TITLE: **PRELIMINARY PLAT NO. 01006, APPIAN WAY,** requested by the Kent Seacrest on behalf of Andermatt, L.L.C. and Eiger Corporation, for 28 commercial lots and 8 outlots, with associated waiver requests, on property generally located at South 84TH Street and Nebraska Highway 2.

Re: Preliminary Plat No. 01006
APPIAN WAY

LINCOLN CITY/LANCASTER COUNTY PLANNING STAFF REPORT

Not To Scale
S. 84TH STREET
NEBRASKA HIGHWAY #2
S. 91st STREET
AG
AGR
Exhibit "A"
PROPOSED PUBLIC SIDEWALK
ADDITIONAL PUBLIC SIDEWALK PROPOSED
ADDITIONAL PRIVATE SIDEWALK PROPOSED

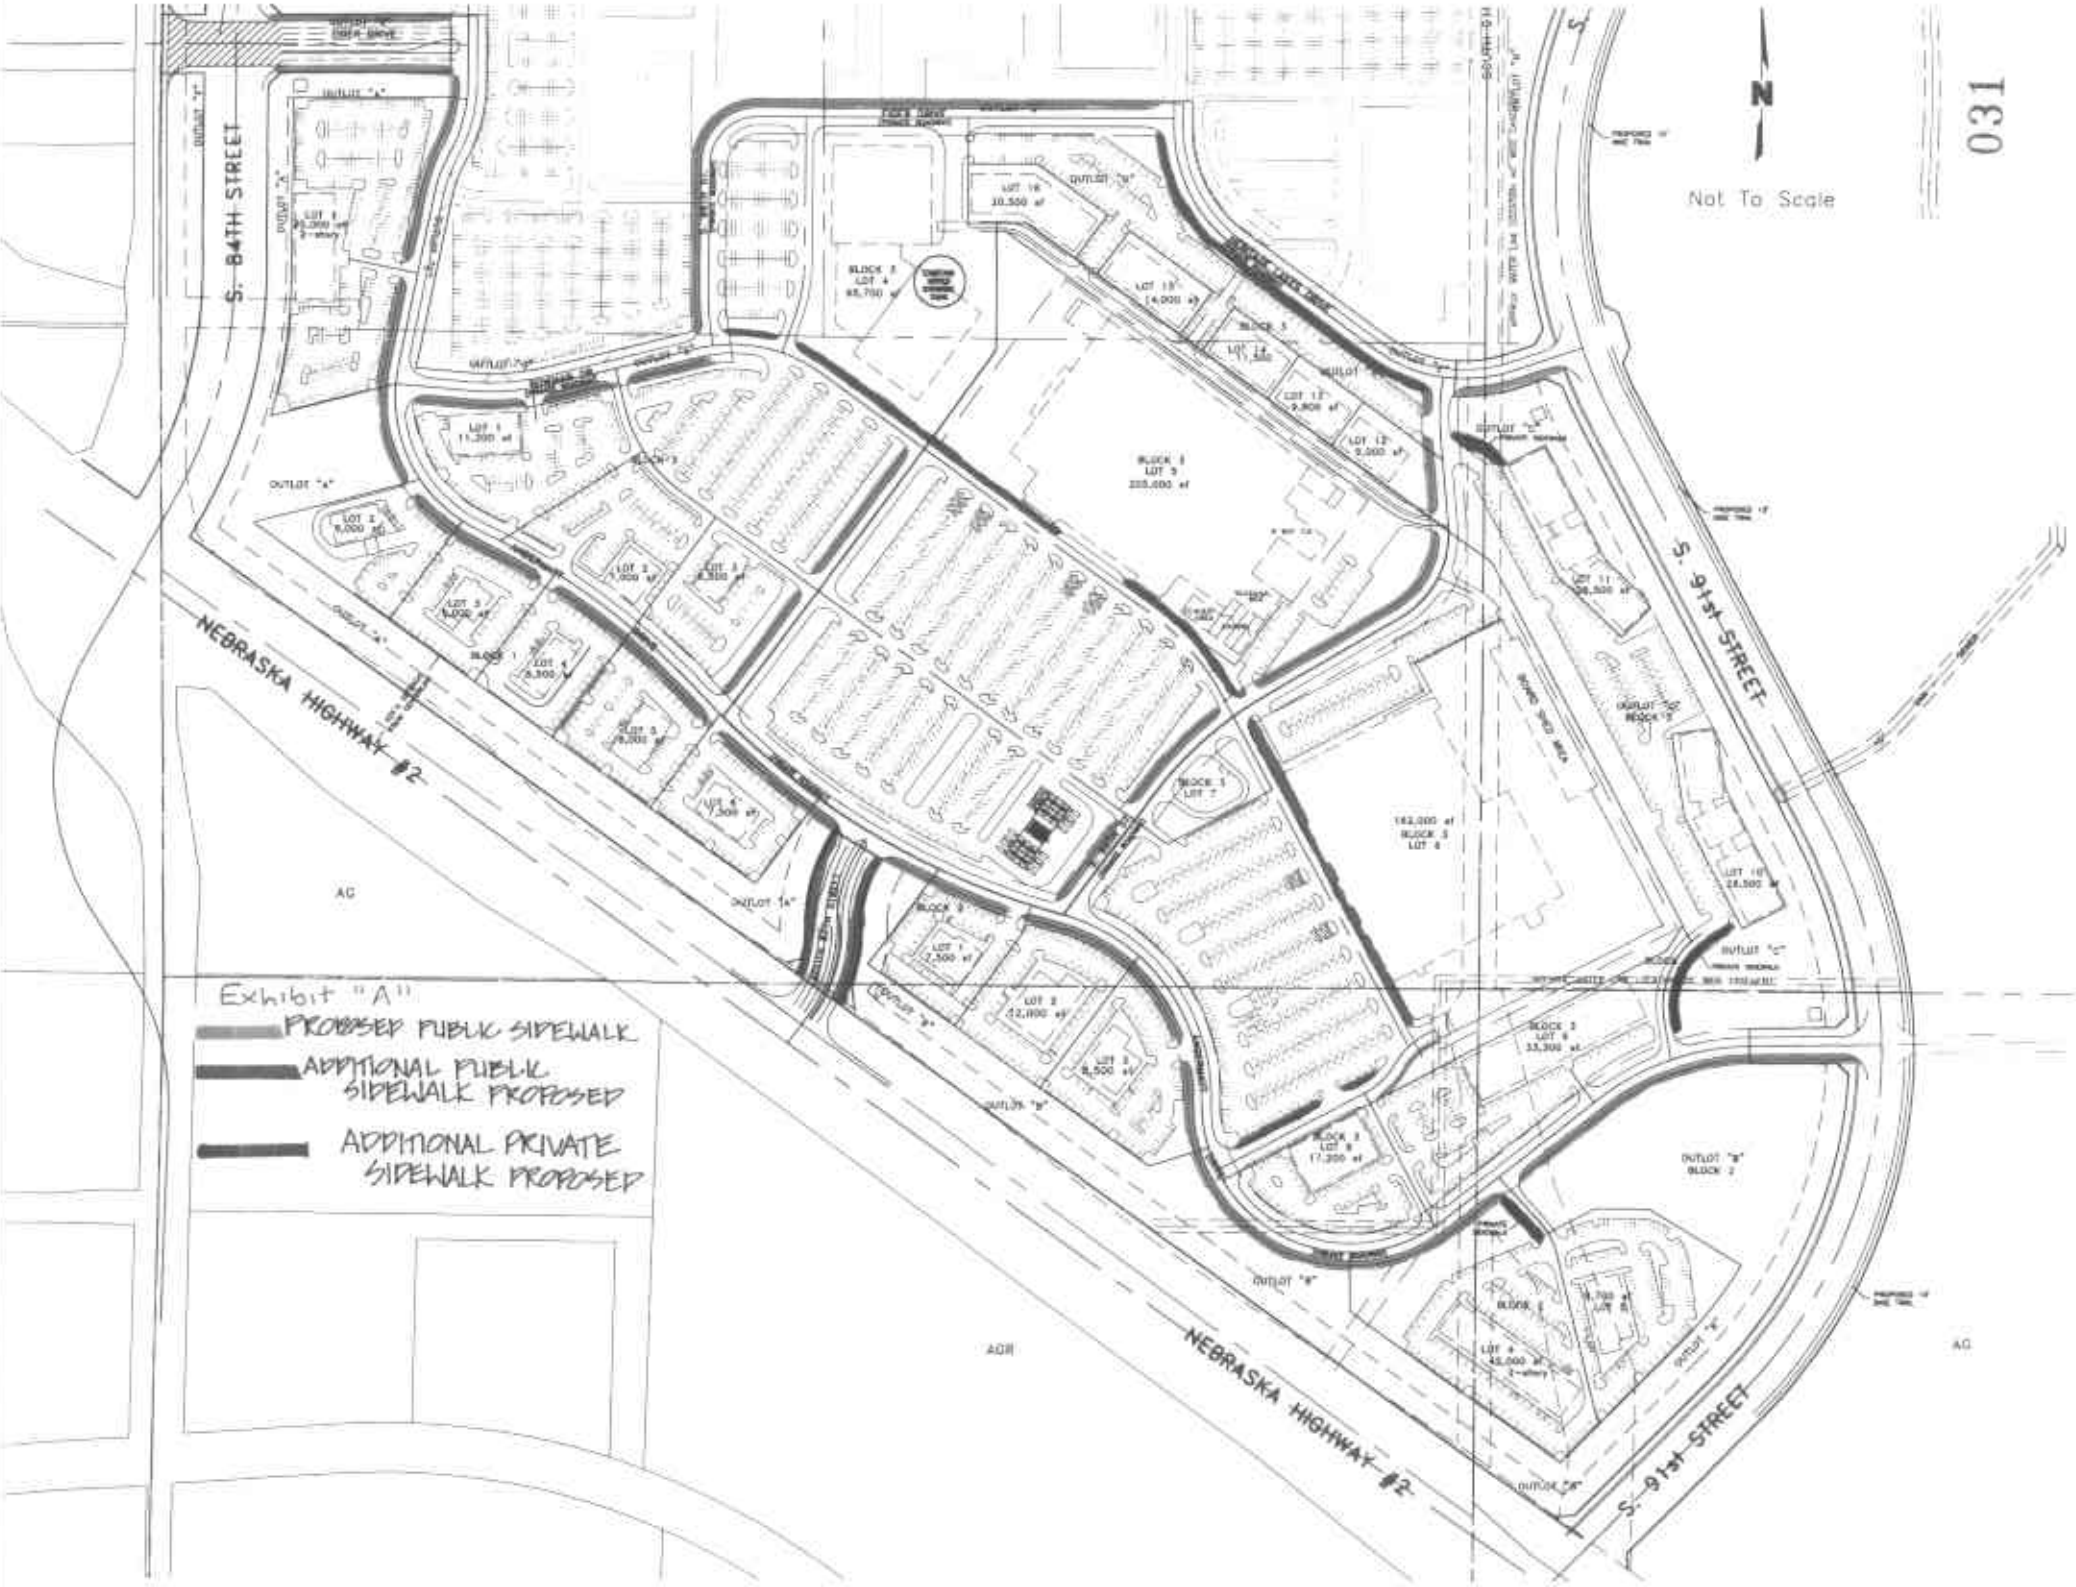
4. The applicant's testimony is found on p.17-21 and 25-26. The applicant submitted proposed amendments to the conditions of approval (See Minutes p.18-19). Exhibit "A" referred to in the proposed amendment to Condition #1.1.1 is found on p.31.

1.1.1 Sidewalks along both sides of all public streets ~~and private roadways~~, except for Highway 2 and S. 91st Street, one side of private roadways in accordance with a cross-section approved by Planning and Public Works Departments, as well as additional pedestrian ways that connect the buildings to the sidewalk system, as shown on Exhibit "A" attached hereto. Sidewalk crossing points shall be located outside of the curb radius. **(**Per Planning Commission at the request of the applicant, with additional language proposed by staff, 9/19/01**)**

With regard to the proposed amendments to the conditions of approval, Reynolds agreed with the amendment to Condition #1.1.1 regarding sidewalks; however, the staff would recommend additional language, "Sidewalk crossing points shall be located outside of the curb radius". This will provide a shorter walking distance for the pedestrian.

Motion to amend to change Condition #1.1.1 to require sidewalks on both sides of the private roadways failed 3-5: Hunter, Carlson and Newman voting 'yes'; Steward, Taylor, Duvall, Bills and Schwinn voting 'no'; Krieser absent.
